APP-GW-GLN-116-NS, Revision 0

“Additional Liquid Radwaste Monitor Tanks and Radwaste Building Extension”

Technical Report 116

**Title:** Additional Liquid Radwaste Monitor Tanks and Radwaste Building Extension

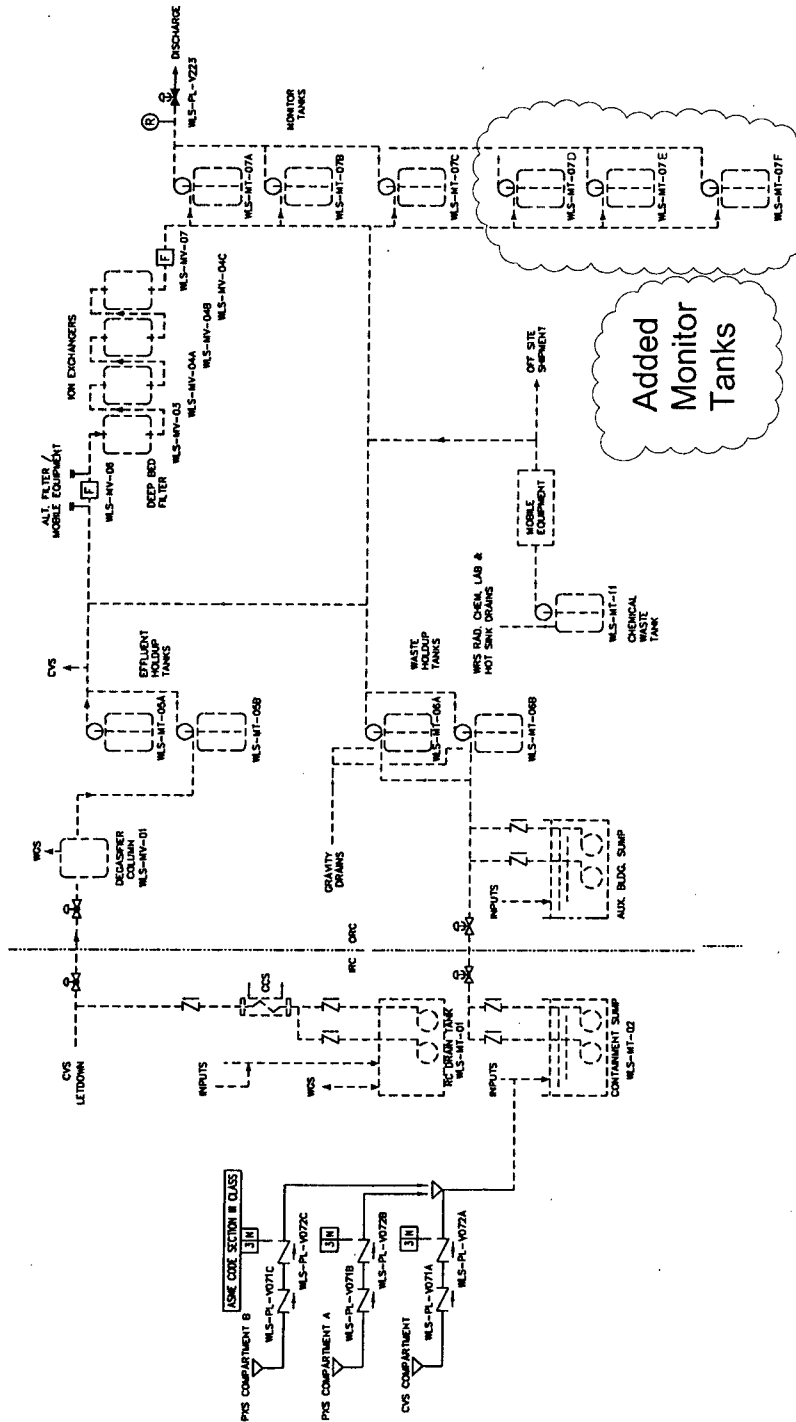
In Tier 1, Section 2.3, add the new tanks to Figure 2.3.10-1 as shown:

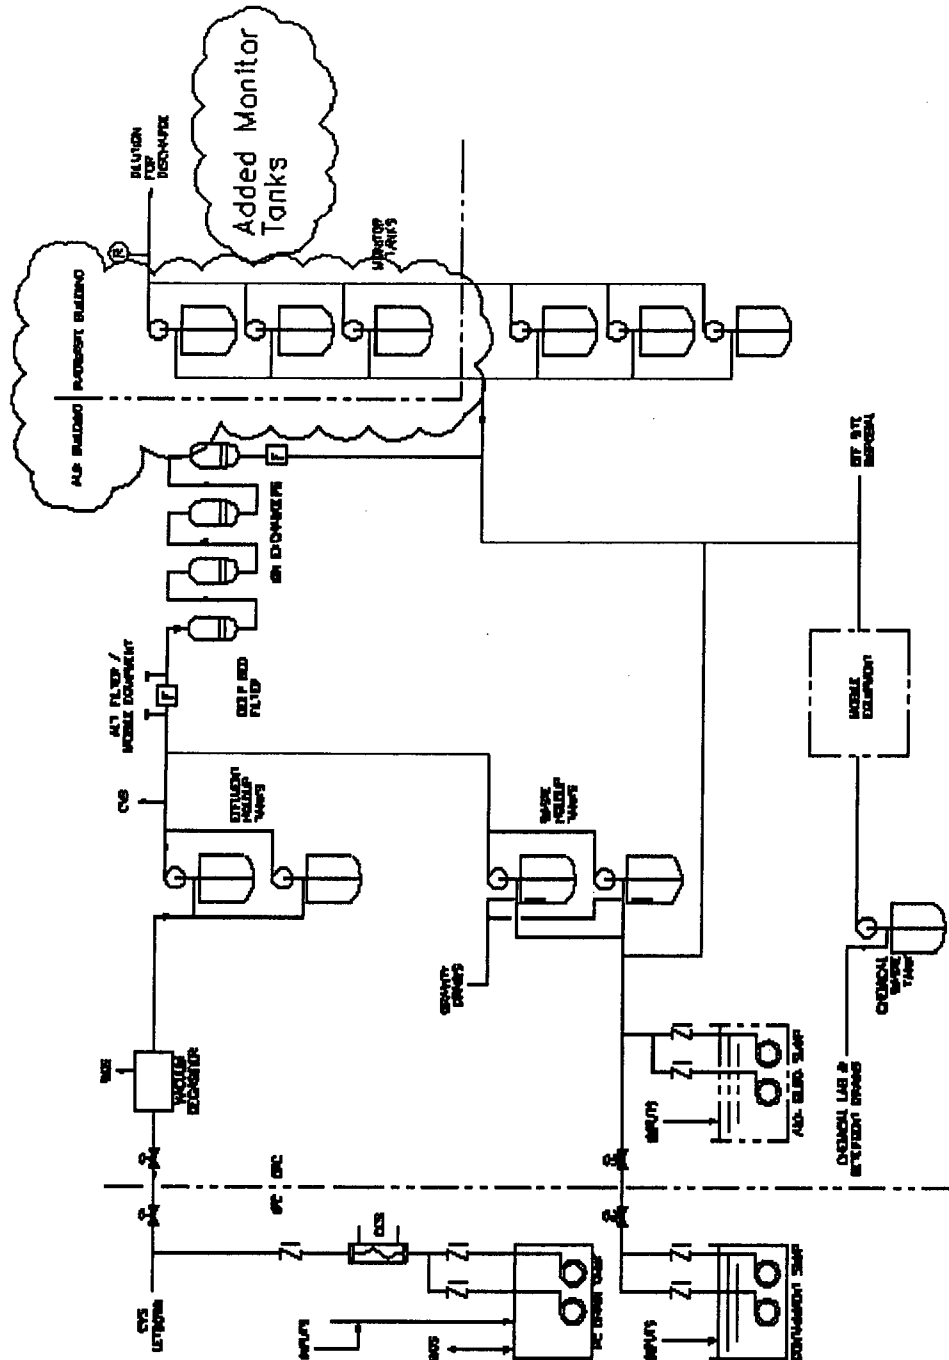
In Tier 2, change Figure 11.2-1 as shown.

Inside Auxiliary Building (Boundaries as shown)  
Figure 11.2-2 (Sheet 5 of 8)

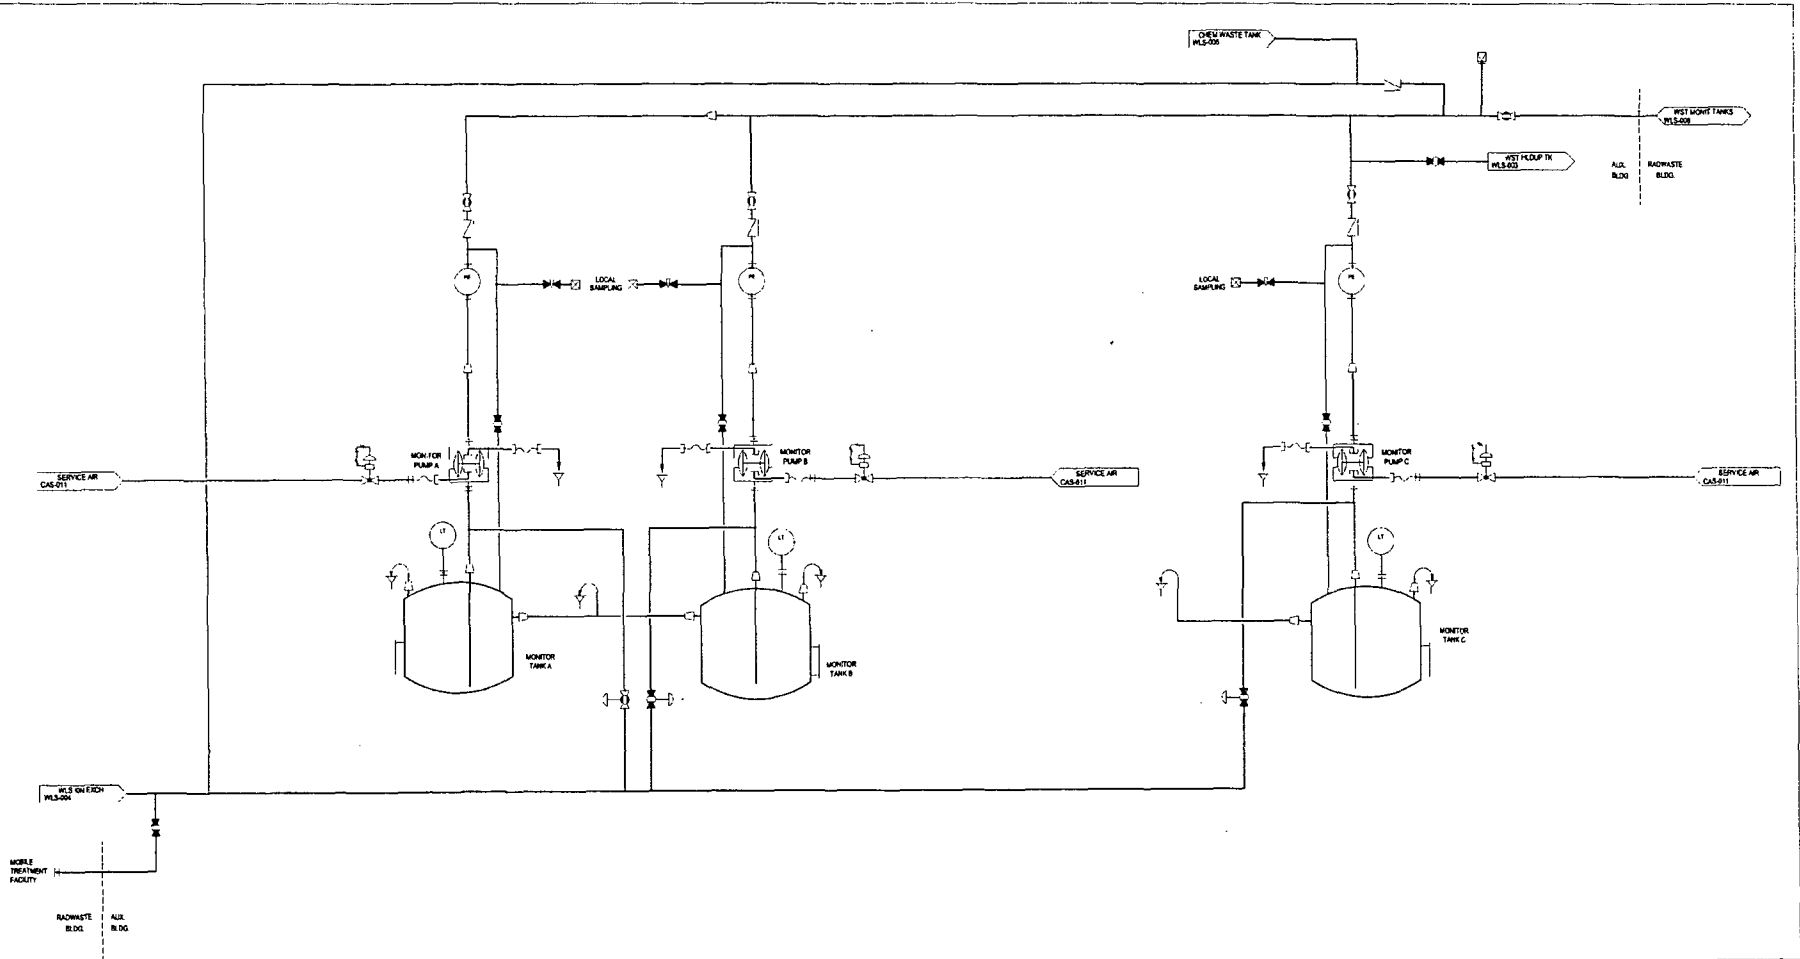
In Tier 2, change Figure 11.2-2 Sheet 5, and add new sheets 8 and 9 to correspond to the revised sheets of the WLS P&ID; see attached figures.
